## **Proposal for Supplement 2 to the 03 series of amendments to Regulation No. 129**

### **Submitted by the expert from Spain**

**Figure 1**  
**Arrangement for testing a forward-facing device**

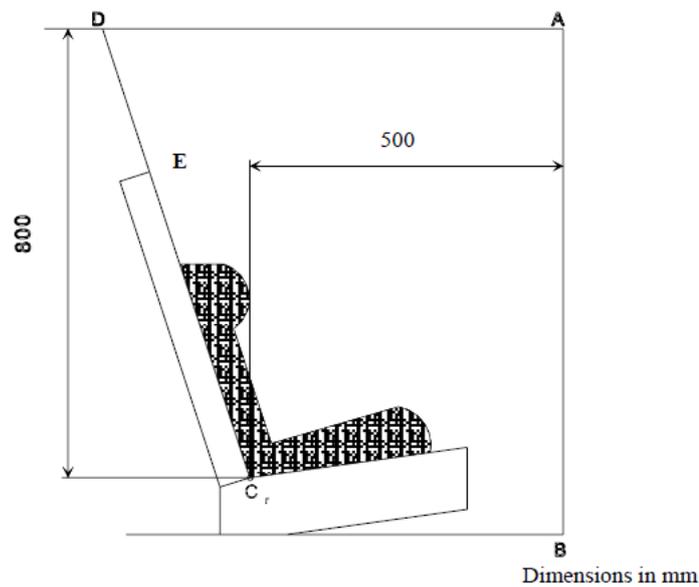
Head excursion: No part of the head of the dummy shall pass beyond the planes BA, DA and DE as defined in Figure 1 below. **However the head of the dummy may pass beyond the DE plane, if there is part of the child restraint structure, i.e. head pad or backrest, behind the head of the dummy, at the point the head passes the DE plane.**"

1. The assessment of the DE plane only applies to rearward facing Child Restraint Systems (CRS) in UN Regulation No. 44. The DE plane assessment remains relevant for rearward facing child restraints in UN Regulation No. 129.
2. For forward facing child restraints, there is often structure of the child restraint, (either head pad or backrest) behind the head of the dummy at the point the DE plane is passed. The energy absorption properties of this structure will have been tested using the test method described in UN Regulation No. 129. Therefore this structure would provide protection to the child's head.
3. It is therefore not necessary to assess the DE plane for forward facing child restraints that maintain structure of the child restraint behind the head of the dummy.
